**REQUEST FOR RECONSIDERATION OF COUNCIL  
RECOMMENDATION**

**36 MURPHY STREET,  
PORT DOUGLAS**

**COUNCIL FILE REF: 8/35/81**

22 February 2010

LOT 2 SITE ACCESS, DESIGN LEVELS & DRAINAGE PLAN

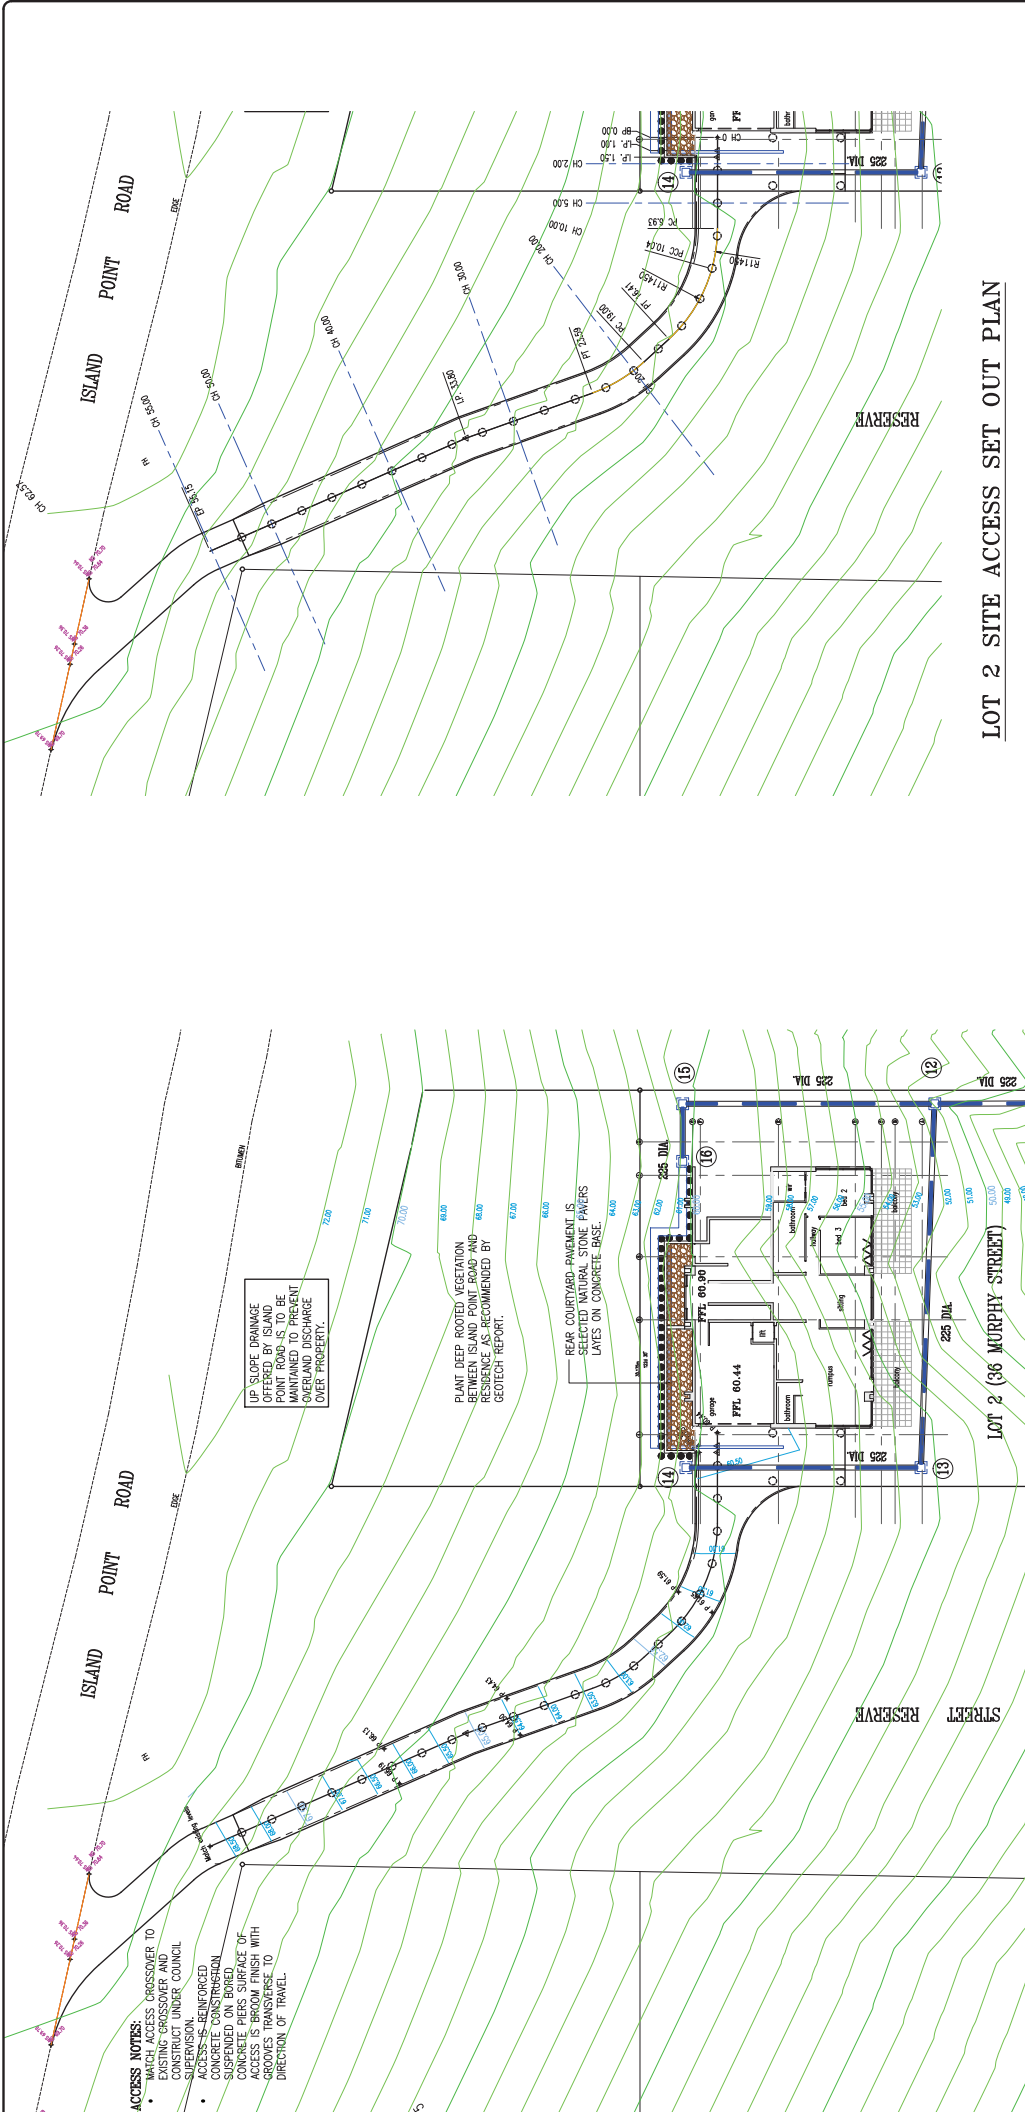
- b. *Provide a revised set of civil drawings which incorporate all the recommendations outlined in Section 7 and Tables 1 & 2 of the Douglas Partners Report (October 2009). The revised plan must detail all works which will be undertaken as part of the development to ensure that the risk classification remains Low as defined by AGS2007.*

- c. *The revised plans must show all retaining and stabilisation structures associated with the development, including access driveways. All structures must be contained within the subject site and should not inhibit the continuation of the access track within the Murphy Street road reserve.*

2. *The applicant is to demonstrate compliance with the proposed stormwater drainage system with the Queensland Urban Design Manual. In particular, details of the proposed navigation and treatment of stormwater from the property boundary to the bottom of the large batter and existing infrastructure on Murphy Street.*

- Deletion of the compacted gravel driveways and inclusion of notation as to treatment of the access ways in accordance with AS2890.1 and FNQROC (S1110) requirements.
- Deletion of the proposed turn around area for Lot 2 within the Owen Street Reserve and relocation within the lot.

NOTE:  
ACCESS IS SUPPORTED CLEAR OF GROUND LEVEL (ON CONCRETE PIERS) FOR THE GREATER PART OF ITS LENGTH (REFER CHANGE SECTIONS SHEET S2) TO AVOID CONCENTRATION OF SURFACE FLOWS AND TO MINIMISE EXCAVATION AND DISTURBANCE TO EXISTING VEGETATION.
